WATER PERMIT NO. 2626-2Name of Applicant: **IRAM**Address: **PO Box 932, Hot Springs SD 57747**Phone: **605 745-6339**Amount of Water Claimed: **1.85**Total Acres: **130 acres**Source of Water Supply: **groundwater (one well)**Water to be used for: **irrigation**County: **Fall River**

Application For Permit To Appropriate Water For Irrigation

**RECOMMENDATION OF CHIEF ENGINEER FOR WATER PERMIT
APPLICATION NO. 2626-2, IRAM**

WATER PERMIT APPLICATION NO. 2626-2
IRAM
FEBRUARY 15, 2008

Type of Map: **aerial**Prepared by: **Kory with Fall River NRCS**Reviewed and the Number Assigned on: **2-5-09**By: **Karen Schlaak**

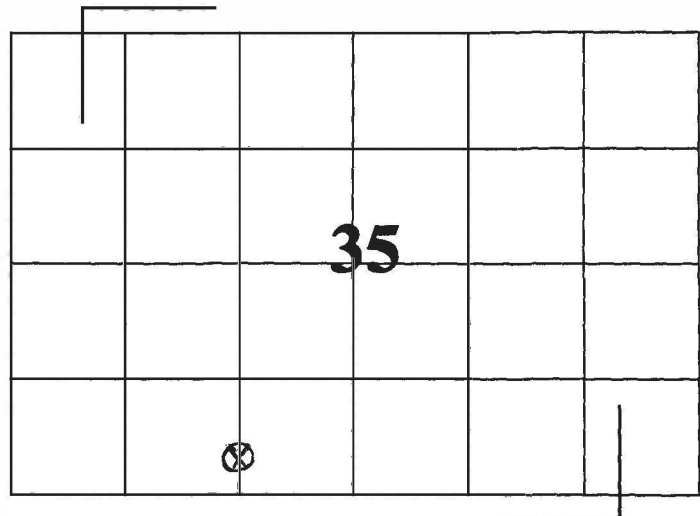
- Enclosed is the aerial photo map submitted with the application. Please mark the proposed location of the well with an "X" and outline the acres to be irrigated. *SEE MAP*

- Item No. 2 of the application indicates the total acreage as 200 acres. Item No. 7 indicates the acreage as 130 acres. Which amount is correct? An additional \$25.00 will be required if you are proposing to irrigate 200 acres. The area outlined on the map needs to correspond with the proposed number of acres to be irrigated.

The Water Rights Program has received IRAM's water right permit application for irrigation in Fall River County. Based on the area outlined on the map submitted with the application, I approximated the number of acres to be irrigated in each quarter-quarter section. The enclosed map provides a breakdown of the acres. Please note that I arrived at a total number of acres of 139 instead of the 130 acres listed on the application.

I intend to amend IRAM's application to reflect 139 acres with the breakdown of acres represented on the map. Please let me know if this is not acceptable to you.

Figure 1. Hydrograph of an observation well completed into the Inyan Kara aquifer approximately seven miles east of the well site proposed by Application No. 2626-2

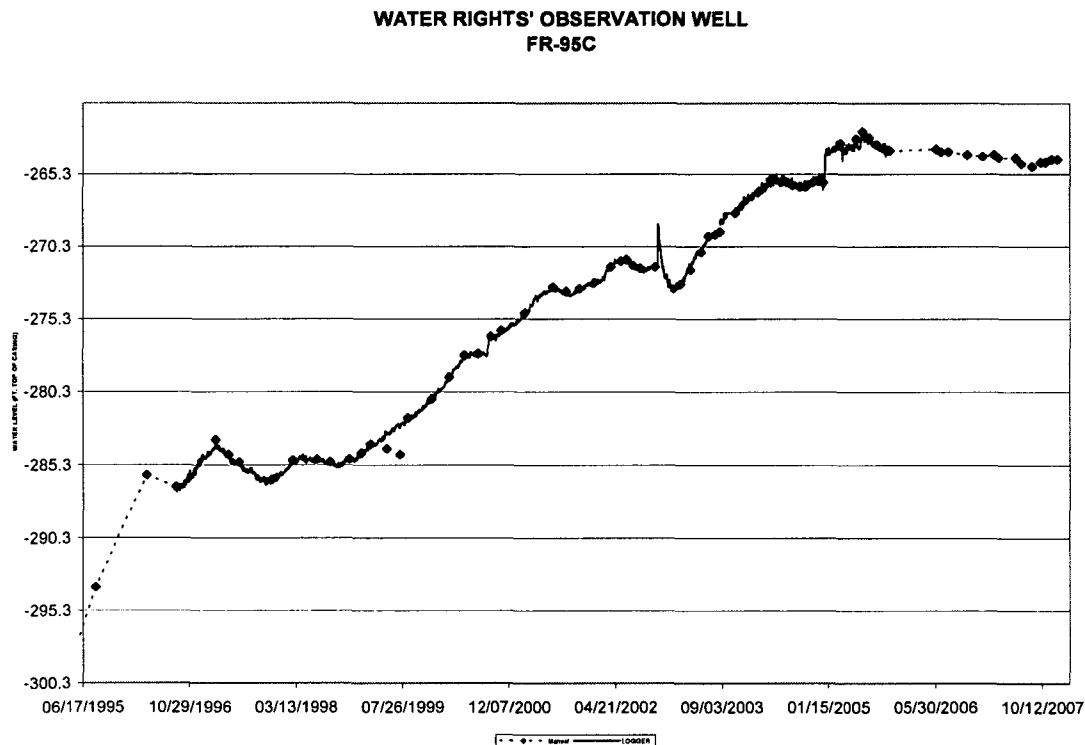
The hydrograph documents that the water level of the aquifer has fluctuated, and in general, has risen about 36 feet over the period of record. It is clear from the data that the aquifer recharges readily (Water Rights, 2008a). The hydrograph indicates water is available for this appropriation.
